Title: AUX FEED WATER PUMP P-38B MINIMUM FLOW RECIRCLINE ORIFICE

PLANT MODIFICATION NO.: 99-029*B

**FINAL DESIGN DESCRIPTION
MODIFICATION REQUEST 99-029*B**

SEAT RETAINER SKETCH

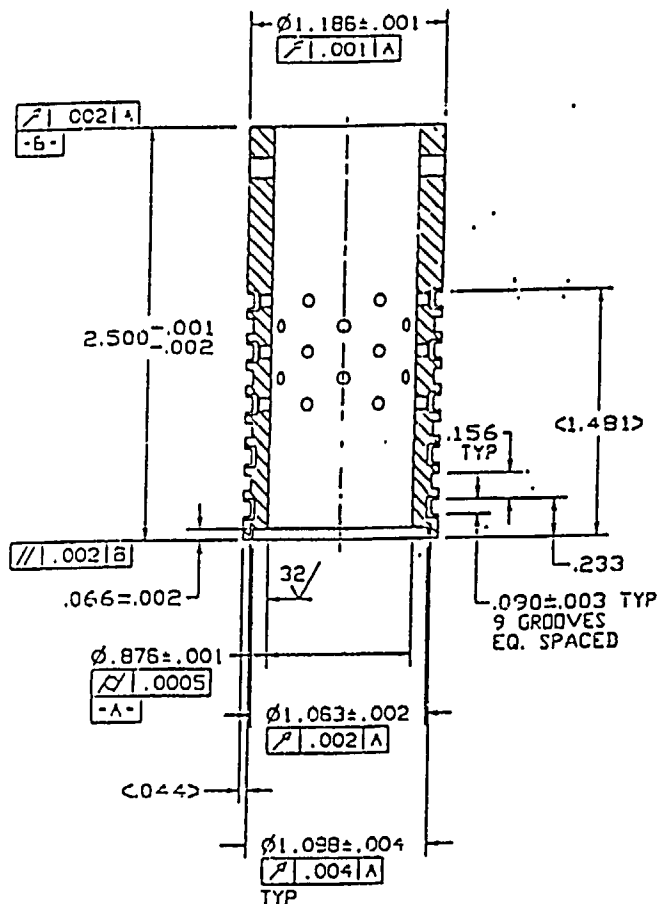
on the attached marked up sketch 1 of the innermost (6th) stage of the seat
retainer (30) and remove any burrs.</p> | <u>MB 11/10-00</u>
MTN/DATE |
